Appendix W – updated September 2018

Note responding to queries raised at planning committee on 19th July 2018 and subsequently updated post the CS11 Judicial Review ruling

18.09.18

Fig. 1 – Site Constraints

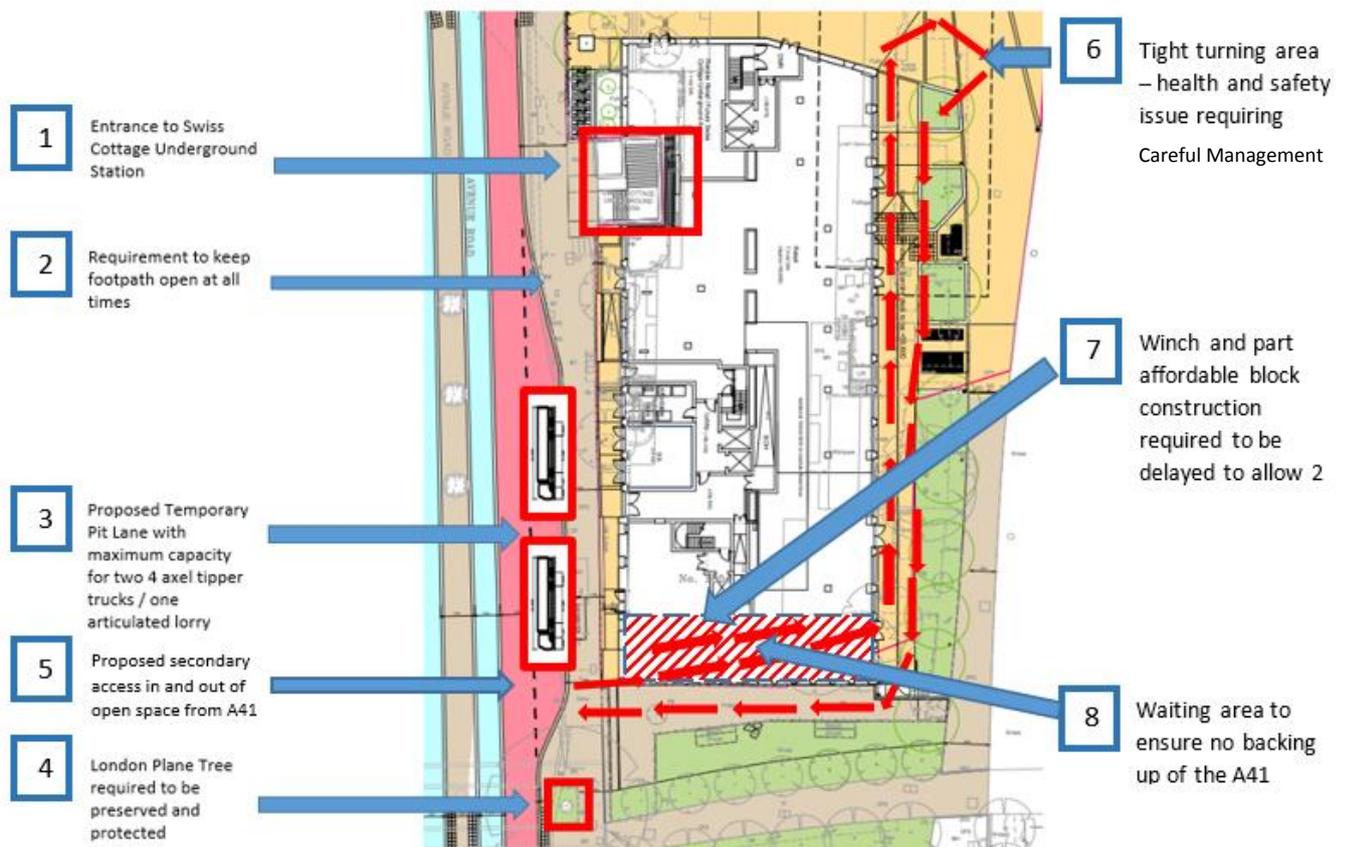
1. TfL’s Objection to Sole Construction from the A41

2. Impacts of a 5 Year Construction Programme

As set out in **Appendix Z** of the CMP we have reviewed many options for accessing the site, with **Fig.1** below setting out the constraints to the access and egress of the site.

The “Pit Lane” is restricted to 28m in length, **(Point 3)** due to the London plane tree **(Point 4)** and bus stop to south, and the Swiss Cottage London Underground entrance **(Point 1)** to the north, limiting the capacity of the Pit Lane to 48 vehicles per day.

Having a secondary access point off the A41 **(Point 5)** is therefore critical to minimising these negative impacts.

As can be seen in **(Point 6 and 7)**, the logistics of having 2-way vehicle movement within a constrained site will be challenging and will require the delay of the construction of the Winch Community space and part of the affordable block until the rest of the site is complete **(Point 7)**, causing a delay in the overall programme.

The use of a 2-way route through this area **(Point 8)** will result in a reduced vehicle capacity on-site compared with a single route through the site due to the increased requirements to pause vehicles whilst others are manoeuvred into position and turned around on-site causing further delay and an increased health and safety risk.

Fig. 2 – Demolition Phase

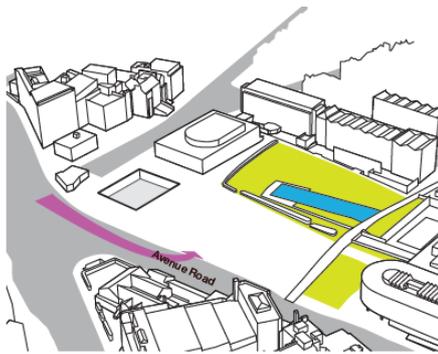
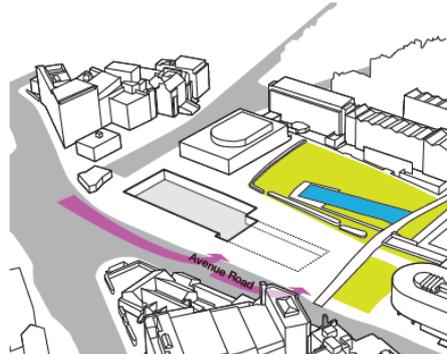
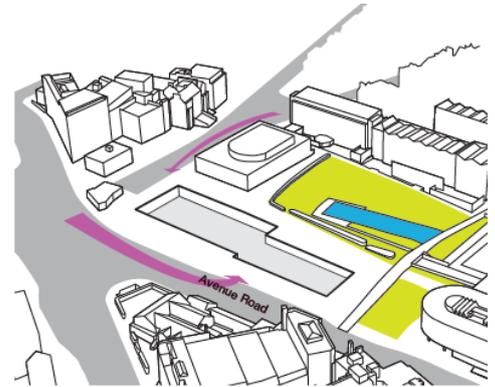
The following phasing diagrams (**Figs 2 – 5**) set out the impacts on each phase of the development when restrictions on access to the project are included:

- Single access point will prolong demolition due to the constraints of accessing the full site and the limits of vehicles being able to remove the waste from site
- Requirement to block lanes off the A41 to allow outrigger lorries access to site impacting bus movements
- High probability of congestion of public highway and conflict with the free flow of vehicle traffic to the detriment of highway safety
- Difficulty to phase demolition works around theatre events as work can only progress from south to north

- Multiple access points allows swifter more efficient demolition reducing impact on local stakeholders
- No requirement for closure of any lanes of the A41
- Ease to programme demolition works around theatre schedule as work can be scheduled to the north or to the south of the site due to 2 entry and egress points depending upon the performance schedules

Fig. 3 – Basement and Enabling Phase

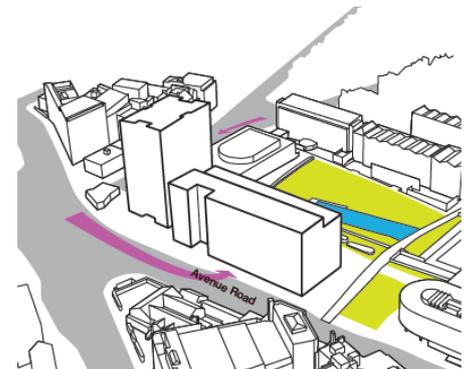
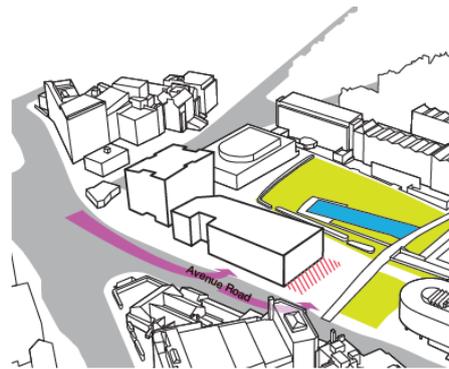
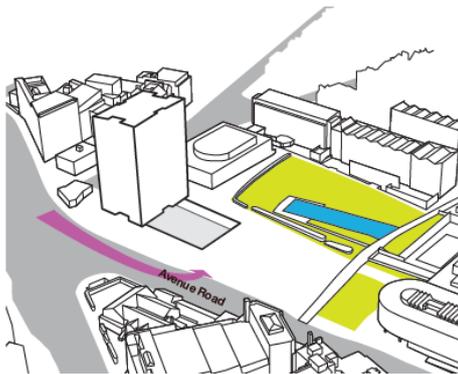
- Impact of restricted access limits the ability to run concurrent activities
- Single point access requires all demolition activities completing before the commencement of any substructure works, which includes enabling and piling activities
- Substructure work limited to tower only
- Single access points leads to a high probability of vehicles backing up onto the A41
- Not supported by TfL

- Two access points off the A41 reduces the risk of vehicles backing up onto the A41 if the Pit Lane reaches capacity but is not supported by TfL's
- Substructure works can be extended but not to the full extent of the area

- Multiple access points allows concurrent activities, resulting in a more efficient excavation phase
- Substructure works may commence on both blocks simultaneously
- No backing up of A41 or requirement to shut any lanes

Fig. 4 – Construction Phase

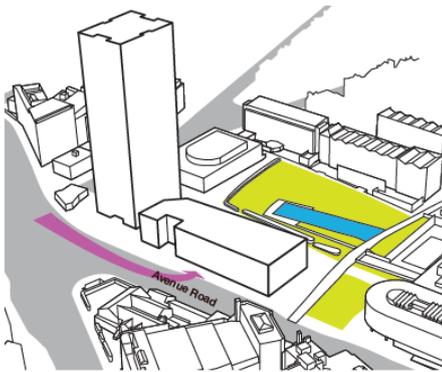
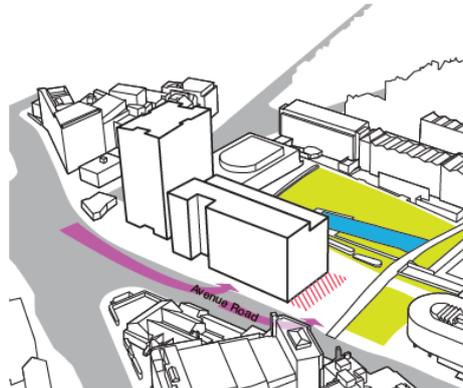
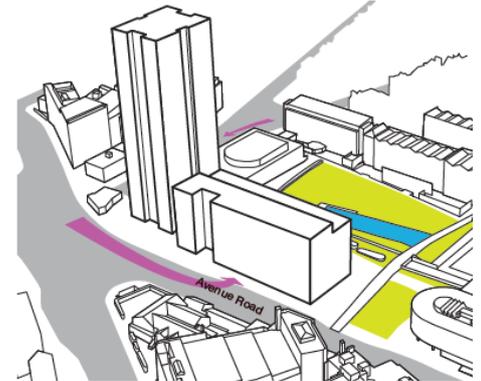
- Requirement for lower building area to be used as construction material lay down area due to limitations of pumping concrete over a large distance, resulting in the need for a static concrete pump
- Further delays will be caused by the requirement to double handle materials from the lorries to the construction lay down area and finally to the tower leading to inefficiencies
- The construction of the tower will therefore be built prior to any commencement works of the lower block

- Two access points off the A41 means superstructure works may commence on the tower and part of the lower block
- Part of the lower block (part of the Winch and Affordable Block - hatched red) is required to be delayed to allow vehicle access to the rear of the site
- Concrete for both blocks can be poured directly from wagons resulting in a quicker build than a single access point but delays to the lower block prolonging the overall programme

- Multiple access points means superstructure works may commence on both blocks at the same time
- Concrete for both blocks can be poured directly from wagons resulting in a quicker build and less space to be used for construction materials
- Multiple routes is the most efficient method resulting in the quickest and safest programme

Fig 1. Interim Layout
CS11 delayed 3 – 6 months

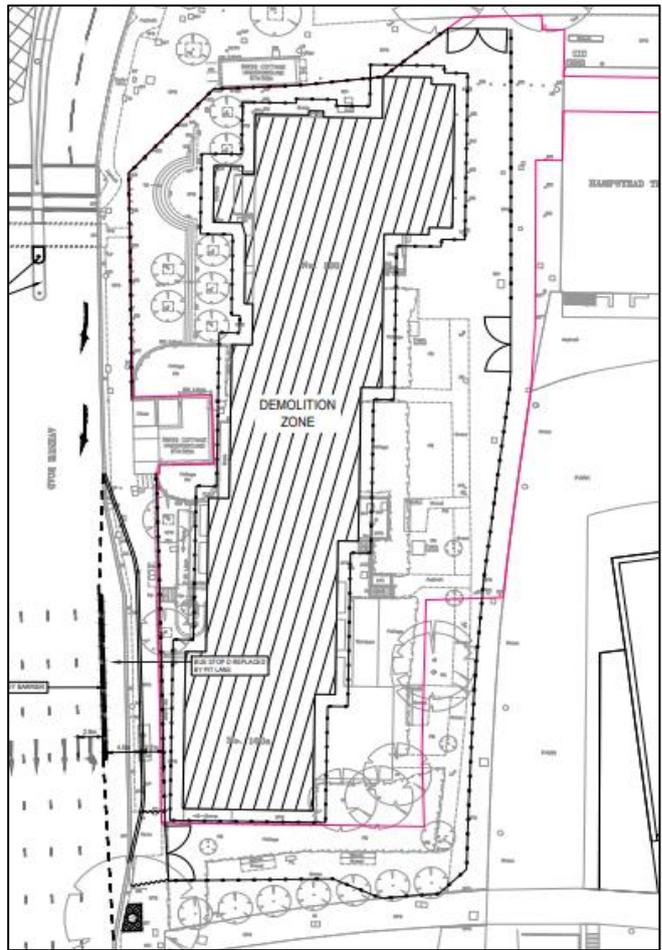
3. Judicial Review of CS11 Scheme

Essential Living is aware that the CS11 Scheme has been Judicially Reviewed and that TfL are now reviewing their options.

In summary, should there be a prolonged delay to introducing the Pit Lane, an interim layout for Bus Stop D (adjacent to the development site) provides drivers a safer exit from the site onto the A41 but also allows for a limited number of vehicles to access the site from the A41. This is shown in Fig 1 below.

Should the CS11 scheme be delayed further, the Pit Lane will need to be introduced within the existing layout of Avenue Road. See Fig. 2 below. With Bus Stop B being enhanced to absorb the buses diverted from Bus Stop D

Fig. 10 – Proposed root mitigation measures

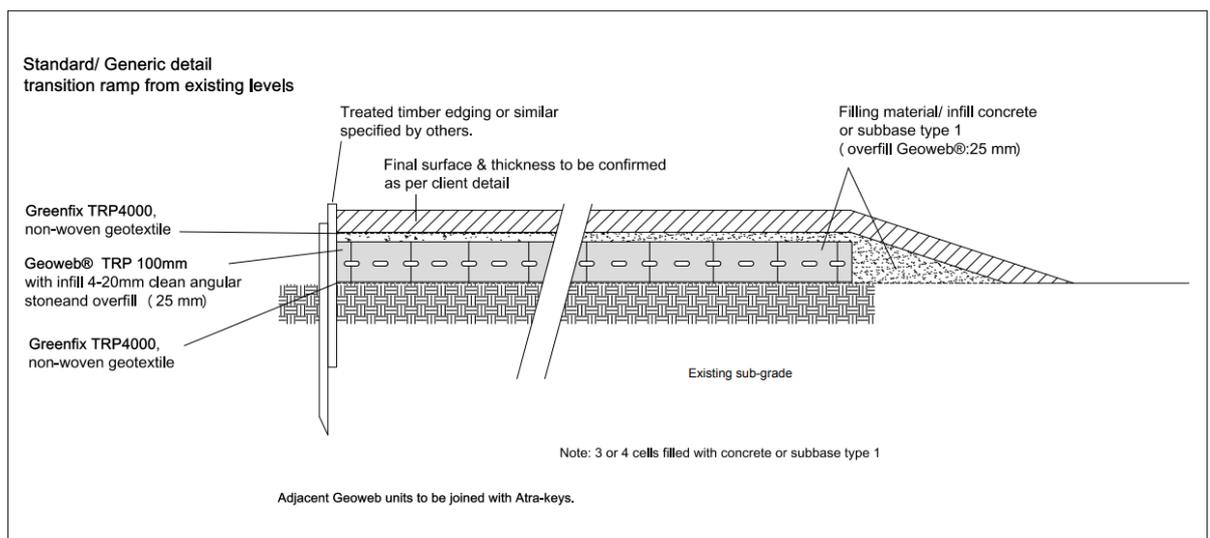
6. Tree Protection

The London Plane tree on the pavement of the A41 is not within Essential Living’s demise, and is a Highway Tree. However this tree will be a priority to protect due to its proximity to vehicle movements. We are committed to its protection and will seek full agreement to our protection measures proposed as part of the CMP.

Essential Living will commit to further exploratory research on tree root zones beneath the pavement surfacing and the appropriate barriers, matting and/or bridging to be put in place in order to protect this tree.

A full method statement will be provided with measures likely to include a transition ramp with matting (as shown below) to protect the tree roots along with tree barriers to protect the trunk.

Fig. 12 – Proposed Market Alignment

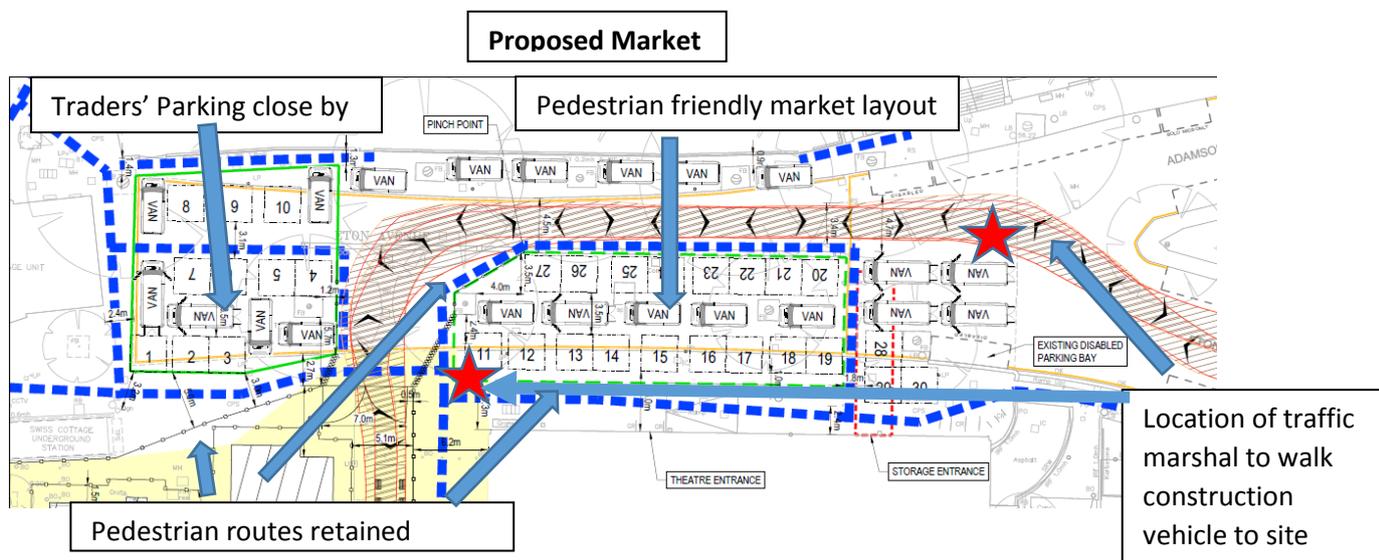
9. Market Officer Proposed

The proposal seeks to create a pedestrian friendly market 'street' with the market traders' vehicles parked away from the stalls. To effectively implement this, EL has undertaken to take steps to provide electricity supply to the stalls.

In addition on Wednesdays, the busiest day, Essential Living will fund an additional market officer to assist setup/pack up. It is our understanding that for the remainder of the week limited stalls are present and on-going discussions will take place over whether additional resources will be required.

The rationalised market layout is below with a more detailed plan provided in **Appendix AB** of the CMP.

This amended market layout will be permanent in order to maintain a clear access route to the site for emergency services as well as Camden Council's park maintenance team post demolition phase.

Fig. 13 – Alternative Options Considered

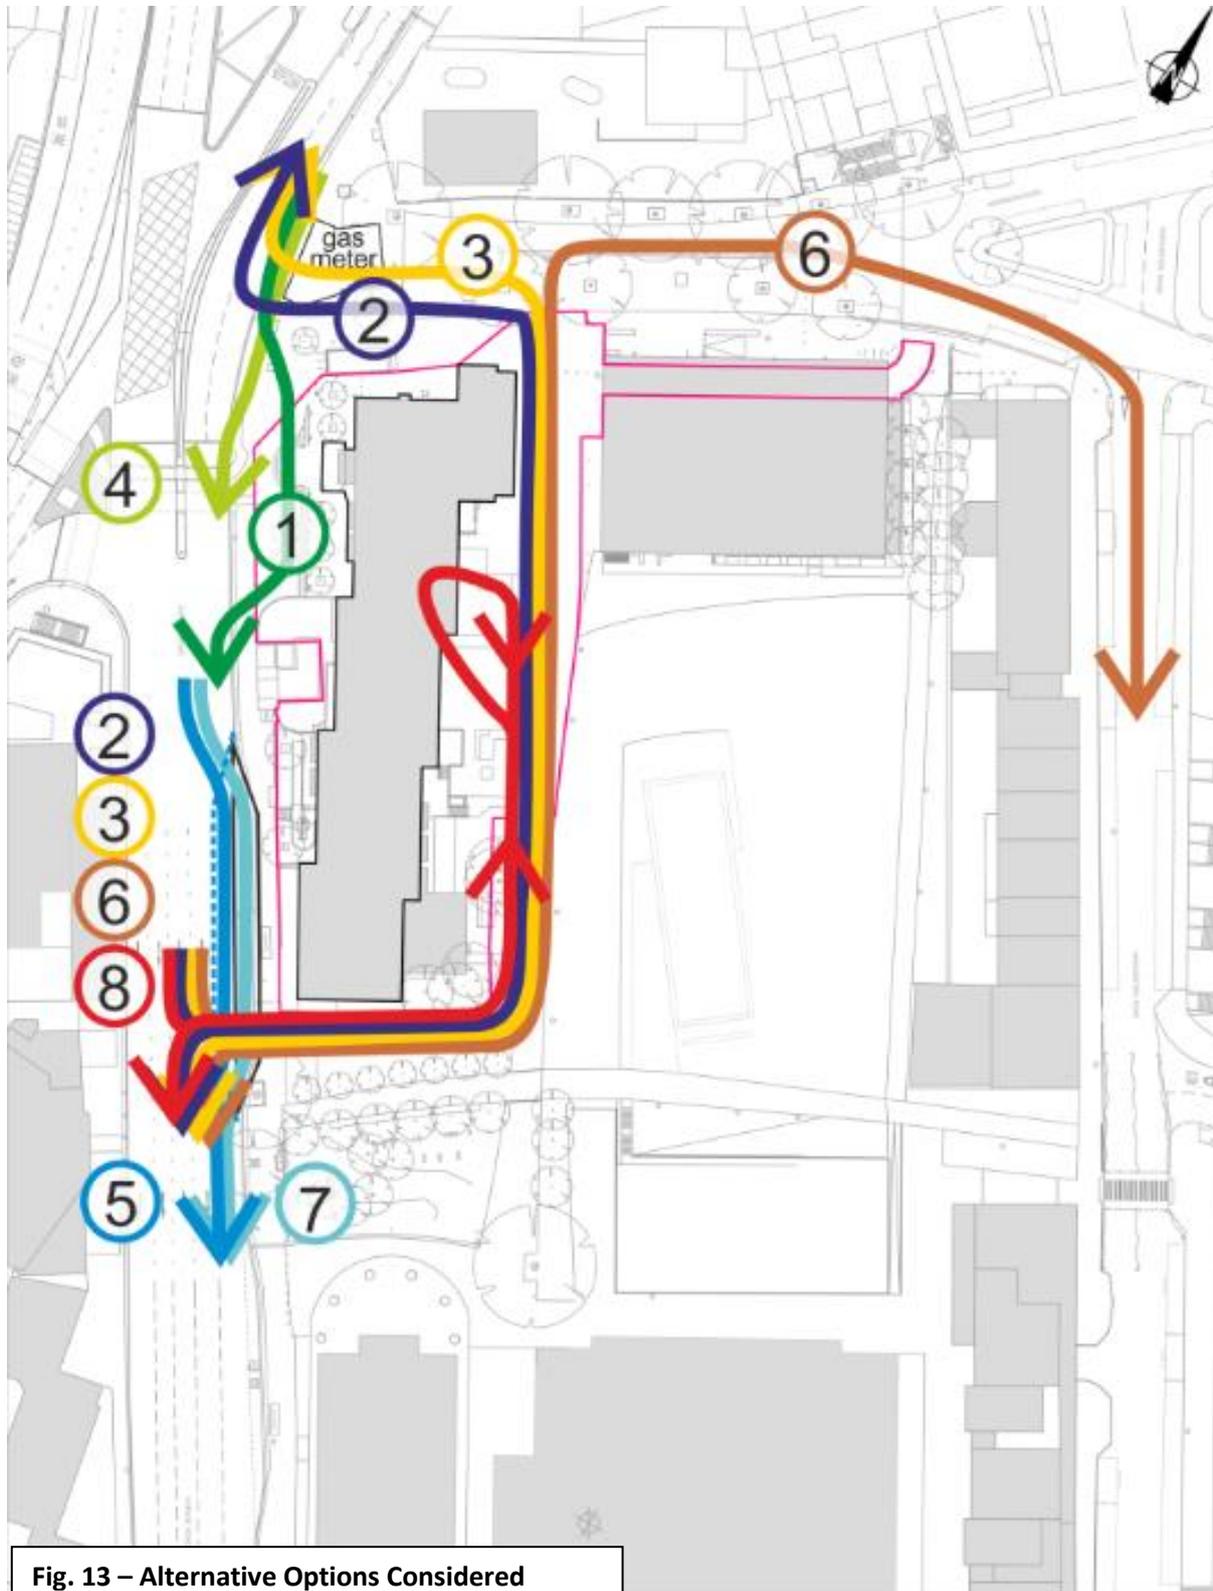
10. Alternative Access Options Considered

A summary of each option is as follows.
